SHOP DRAWING SUBMITTAL REVIEW

CBWTP SECONDARY TREATMENT
EXPANSION PROGRAM

BLOWER BUILDING
HVAC
OVERALL ROOF PLAN

GRID
JOB NO. E07947
SHEET NO. 40H102
432 OF 1252

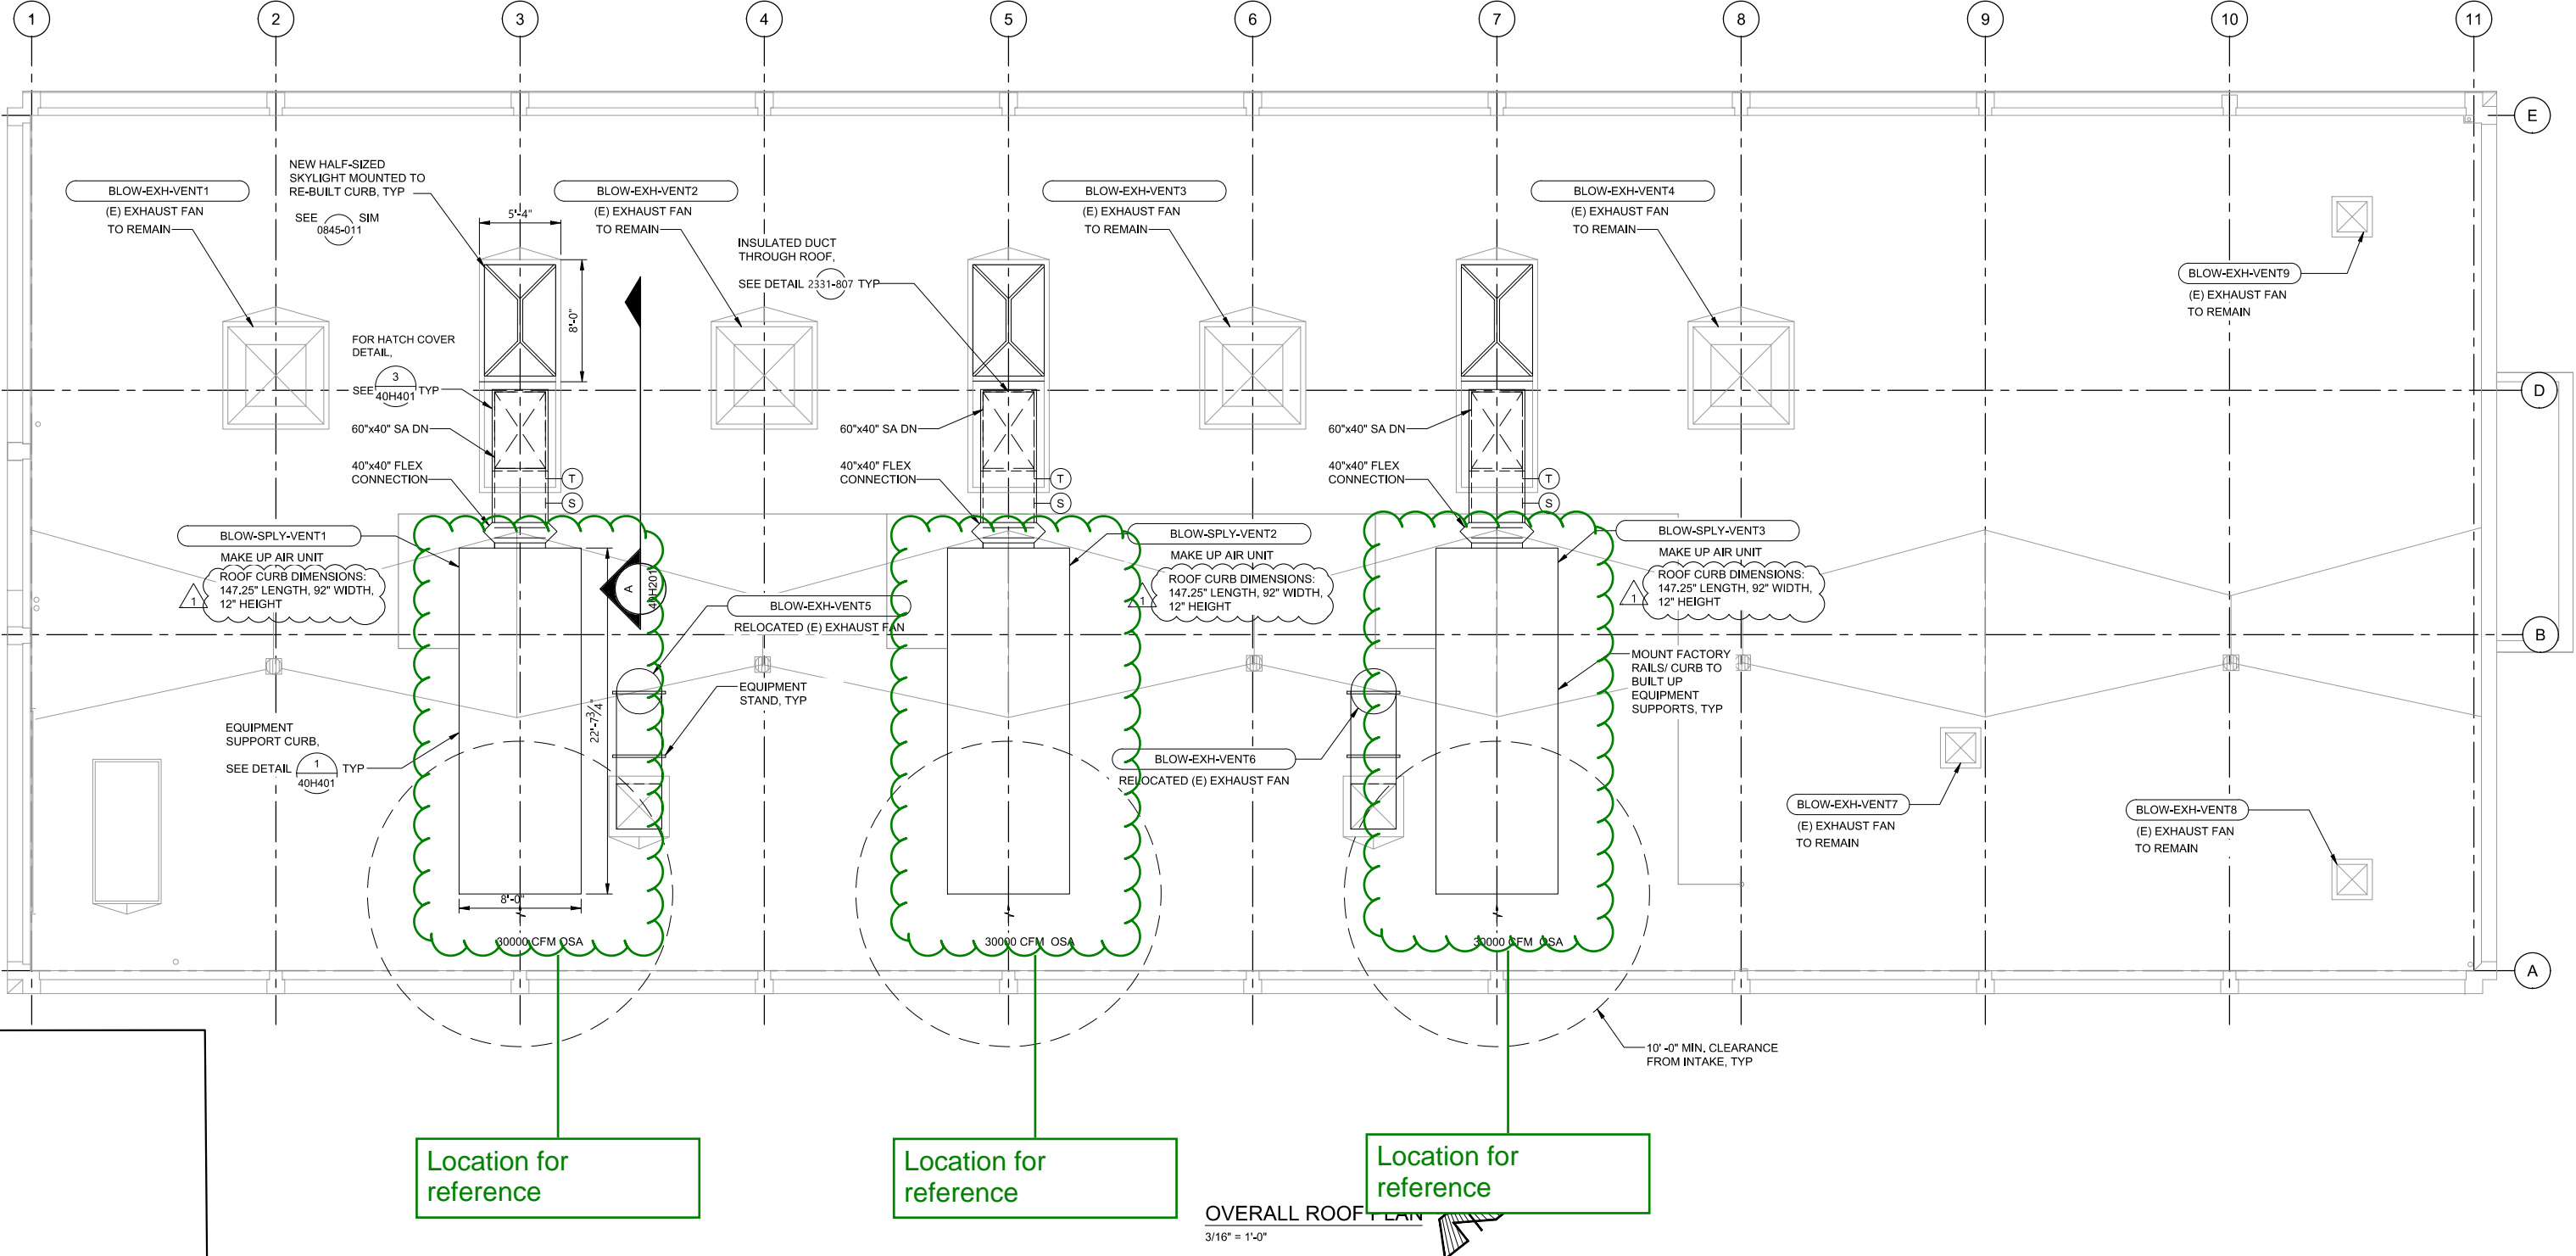
EOR Please review & add submittal review stamp if acceptable. Deferred submittal process requires submittal review stamp on the shop drawings & calculations

☒ NO EXCEPTIONS TAKEN ☐ MAKE CORRECTIONS NOTED
☐ REVISE AND RESUBMIT ☐ REJECTED
